Reply to Reviewer 1 (H. Bogen)

This manuscript presents a network-wide parameterisation to estimate snow water equivalent (SWE) using cosmic ray neutron sensing (CRNS) across sites in the Italian Alps.

Brief communication: Shared parameterisation for estimating snow water equivalent through cosmic ray neutron sensors in the Italian Alps

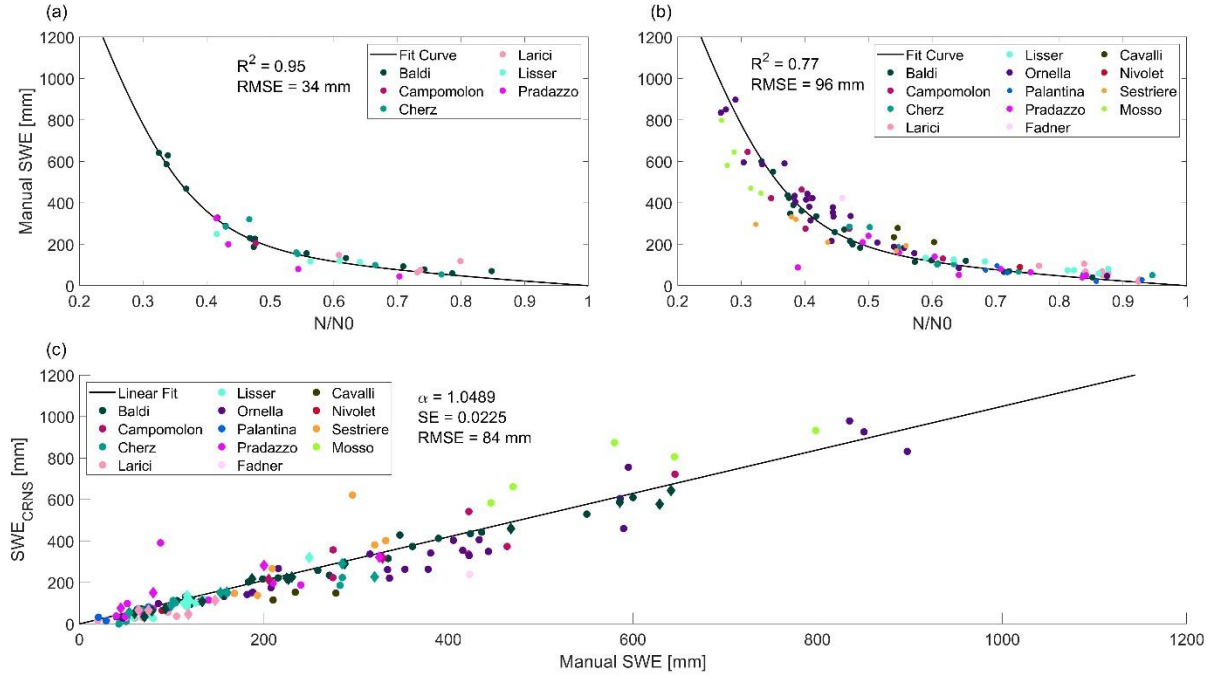
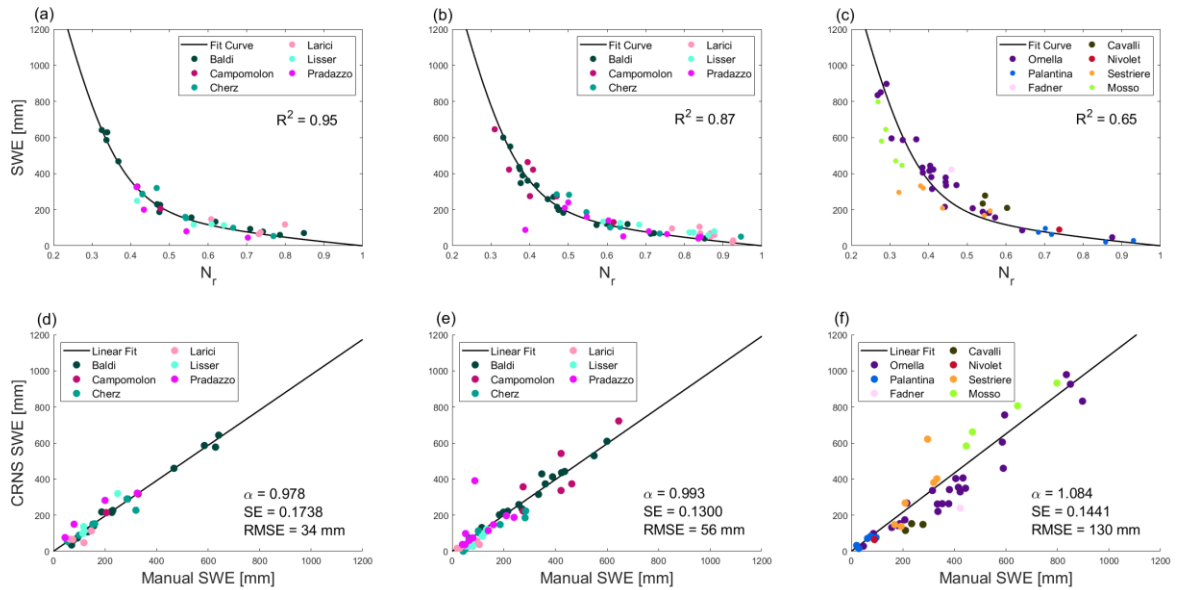
From the 26 sites, only 6 sites were used for calibration and 13 sites for validation. In its current form, the narrative risks implying broader validation than is actually demonstrated, e.g. from the title and the abstract. The authors should clearly and consistently distinguish between (i) the full network, (ii) the calibration subset, (iii) the validation subset, and (iv) sites to which the method is extrapolated. In particular, the abstract and conclusions should avoid wording that could be interpreted as network-wide validation. I recommend explicitly stating the number of sites used for calibration and validation wherever network performance is discussed.

L155: The current validation procedure includes both calibration and non-calibration stations. While this provides an overall assessment of performance, it can potentially overestimate the method’s predictive skill because the calibration sites have already influenced the parameterisation. Therefore, I recommend separating the validation sites from calibration site explicitly.

We thank you for this comment. To address it we propose to change every instance where “network-wide” appears with “shared” (including in the title and abstract of the manuscript). We agree with your suggestions and, to improve the clarity of the manuscript, we propose to divide the data and results shown in the following subsets: (i) calibration data (6 sites), (ii) validation data from the same sites used for calibration, and (iii) validation data from (7) additional sites of the network. This modification will be applied both for the methodology description of Section 2 and the results of Section 3 as well as in Figure 2.

L187-188: The validation dataset (Fig. S3) is divided as: (i) manual samples from the same sites chosen for the calibration, and (ii) manual samples from the 7 additional monitored sites of the network.

L220-221: R^2 values obtained for the calibration, validation at sites of calibration, and validation at additional sites are 0.95, 0.87, and 0.65 respectively.

L236-239: Remarkably, both the slope and the SE obtained for the validation subset at the sites used for calibration (Fig. 2e) appear to perform better than the calibration subset (Fig. 2d). Nevertheless, RMSEs sensibly increase across the three subsets from 34 mm of the calibration subset to the 130 mm of the validation subset in the 7 additional sites. The latter subset shows also an α further from 1 (1.084) and an higher SE (0.1441).

L293-294: on the same sites chosen for the calibration ($R^2 = 0.87$, RMSE = 56 mm) as well as in seven additional monitored sites ($R^2 = 0.87$, RMSE = 130 mm). ~~($R^2 = 0.77$, RMSE = 96 mm).~~

We acknowledge that and have chosen to modify Figure 2 to explicitly separate the sites of the validation dataset.

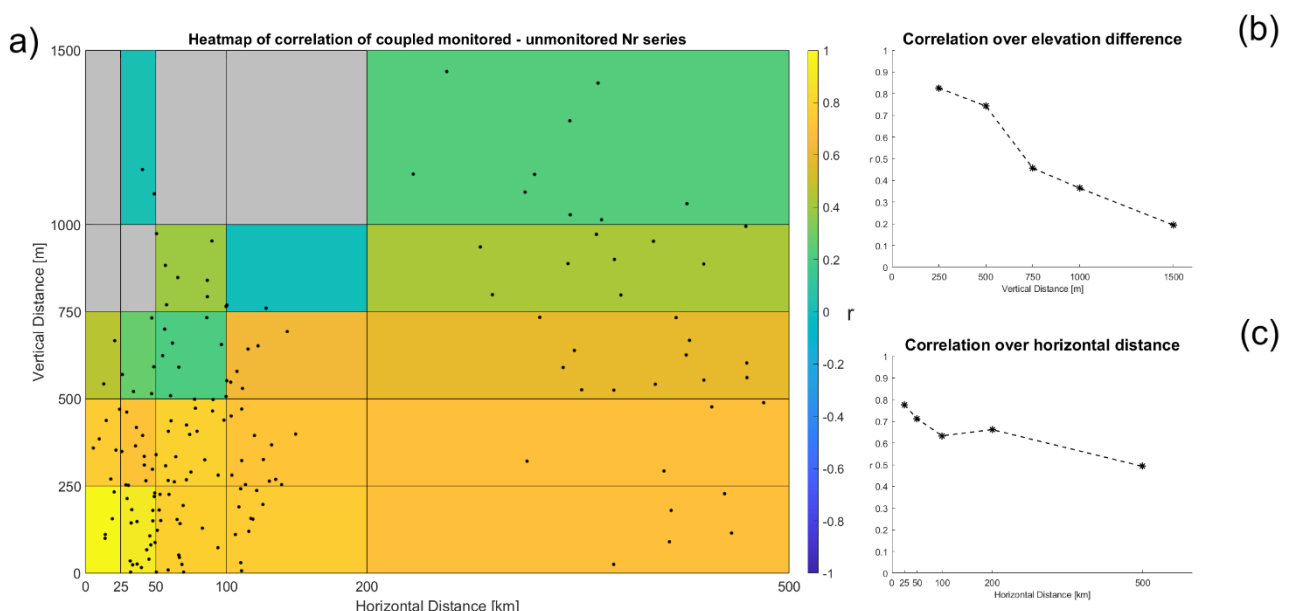
L197-203: In my view, this correlation analysis is only meaningful if each station has been individually calibrated. Otherwise, the uncertainties introduced by transferring the parameterisation across sites may dominate the variability and artificially inflate or suppress correlation values.

We acknowledge your comment, however the same analysis performed using the N_r time series (which are independent from the subsequent parameterisation) showed similar results. We are open to include the figure obtained from the mentioned N_r analysis in the main body of the manuscript but we currently propose to include it in the Supplementary Materials.

L275-276: An analogous analysis conducted on the N_r time series instead of the SWE_{CRNS} ones showed similar results (Fig. S4).

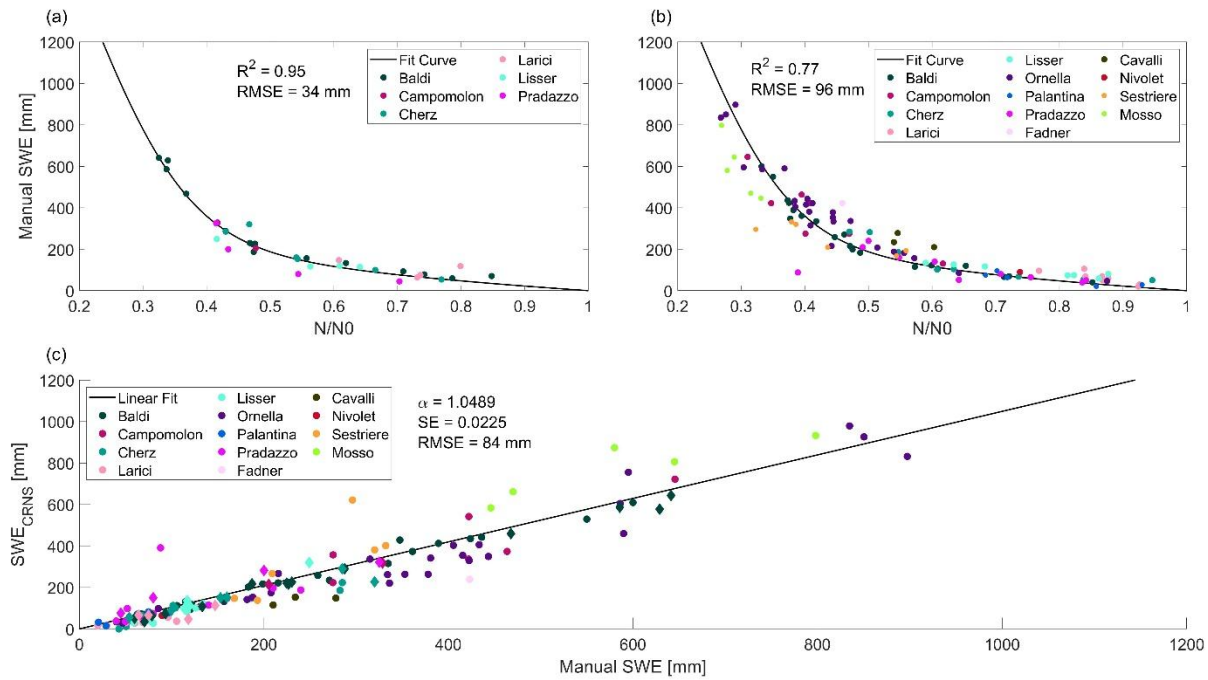
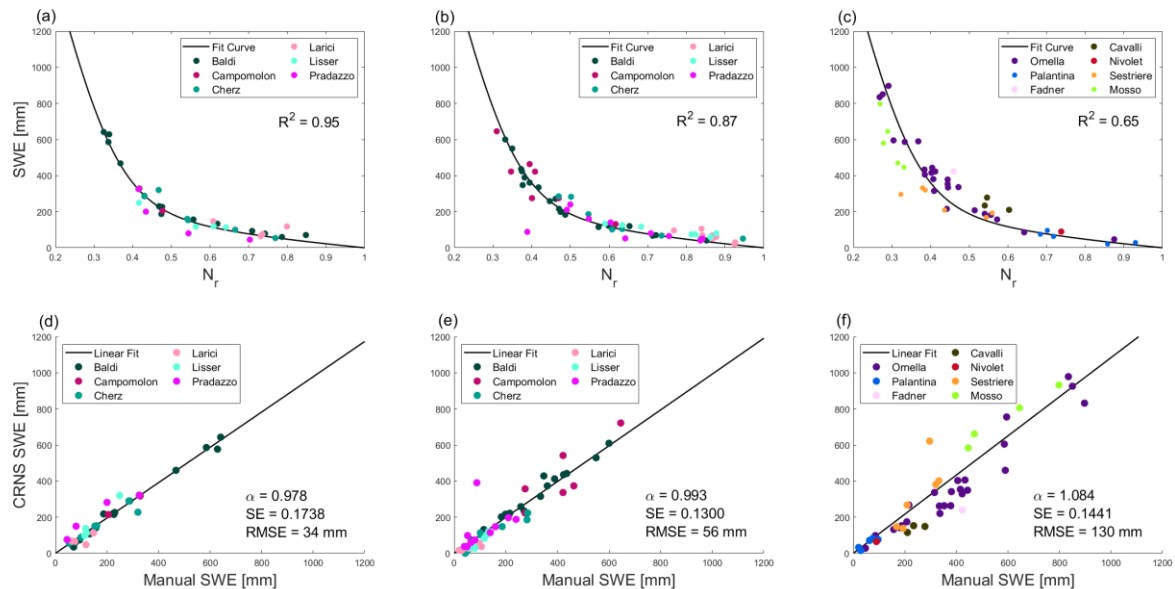
The first results are shown in Figure 2. These are informative. However, it would be useful to consider a different way to show the points, at least the calibration points – I cannot tell some of the colours apart. I suggest using different symbols, and perhaps the elevation colour ramp from Figure 1.

- Figure 2: it should be clearly stated that the curve in (b) is derived from the data in (a).

- Figure 2c: are these the points from (a) and (b) replotted? This is not clear. What are the pink diamonds?

We thank you for this comment. To address a comment by the other reviewer we propose a division of Figure 2 in 6 panels that represent the regression curve and linear fit for the subsets of: (i) calibration data, (ii) validation data from calibration sites, and (iii) validation data from other sites. We believe that this modification may help in distinguishing which data belongs to each site addressing the concerns you expressed.

We thank you for this. We propose to address this lack of clarity in the modified Fig. 2. (See above)

For the Manual SWE they indeed are points from (a) and (b) replotted. However, (c) showed the linear regression of SWE obtained from the regression curve depicted in the other panels where diamonds represented calibration data (maintaining the colours assigned to the stations in the other panels). In any case, we believe that lack of clarity pointed out in this comment and in the previous one have been addressed by the proposed changes in Fig. 2 which now clearly separates the data showed in three subsets (i.e. calibration, validation at calibration sites, and validation at different sites) both for regression curve and linear fit.

Figure S1: Distribution showing in which month the manual SWE samplings used for calibration (35 data points in total) were taken.

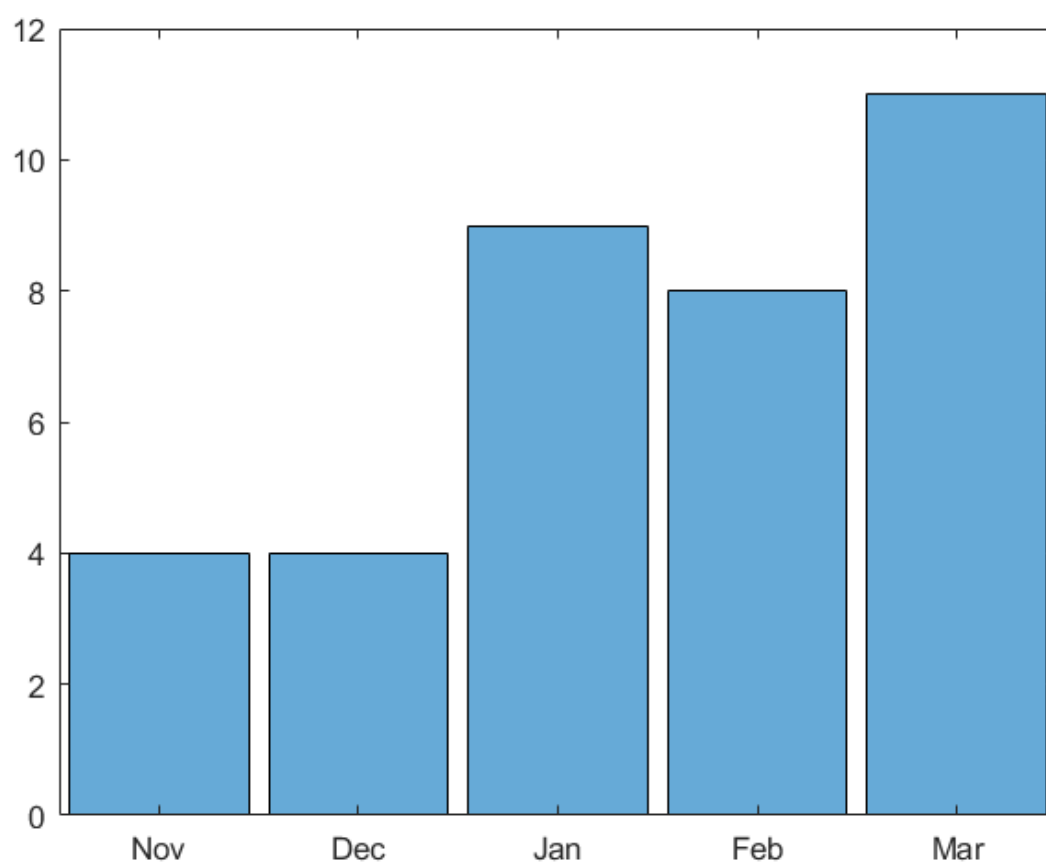
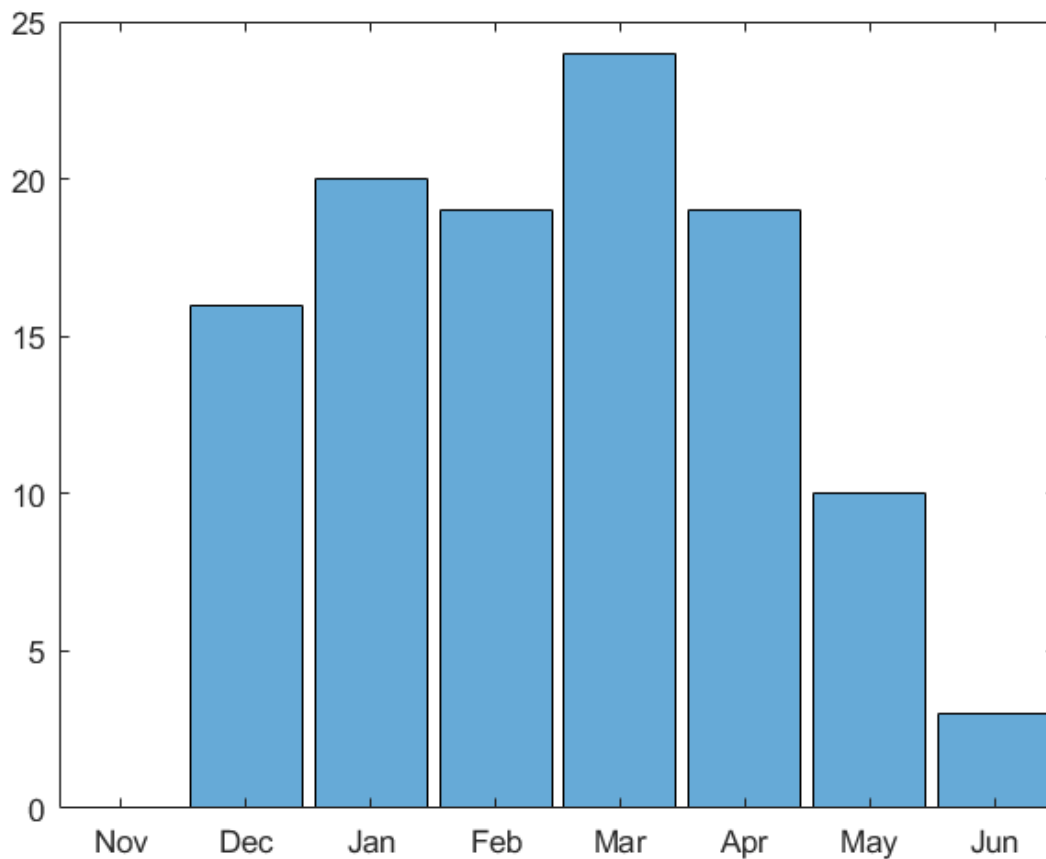
For the Data (and Figure 2), can you provide more information about the 35 location-day samples? A table in an Appendix or Supplementary Materials would be fine. There appear to be 13 samples from Baldi, 3 from Larici, etc. An indication on when these samples were taken would be informative. The calibration station (a) are also used in the evaluation (b). Better explain how and why the data were split into groups.

Thank you for this comment. We propose to add an additional column in Table S1 containing the number of samples taken at each site. Furthermore, we propose to add two figures in the Supplementary Material showing the monthly distribution of the manual SWE samples of the calibration and validation datasets respectively.

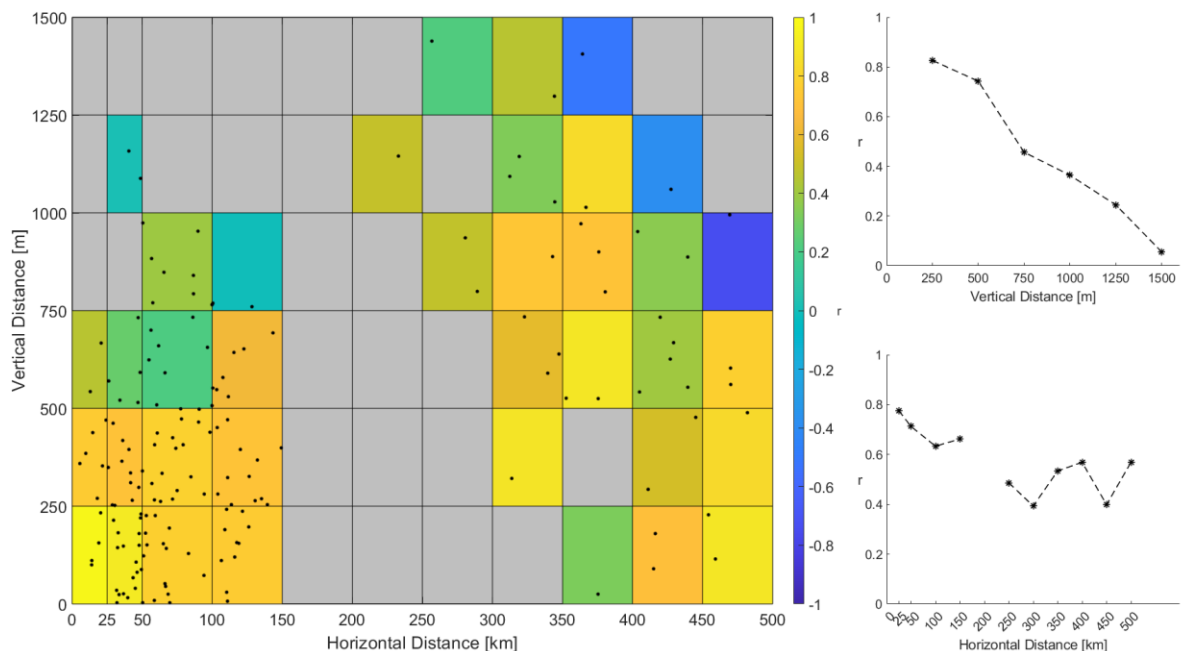
- How do the unmonitored sites fit in? That is not clear. What does unmonitored mean? Does this mean that there are no field SWE measurements? Is SWE computed from the fitted equation?

Thank you for this comment that helps us to further clarify this detail. Unmonitored sites are the sites of the CRNS network that are unreachable during the snow season and, therefore,

lack any manual SWE measurement. SWE time series are computed from the regression curve presented in the earlier part of the manuscript. We believe that an important asset of the network lays in the fact that these probes allow to get SWE data even at sites unreachable during the snow season. Although we recognise that further investigation into the probes performances at these sites are desirable, our intention for the part showing correlations between monitored and unmonitored sites is to provide preliminary steps to guide and inform on additional research on this crucial matter.
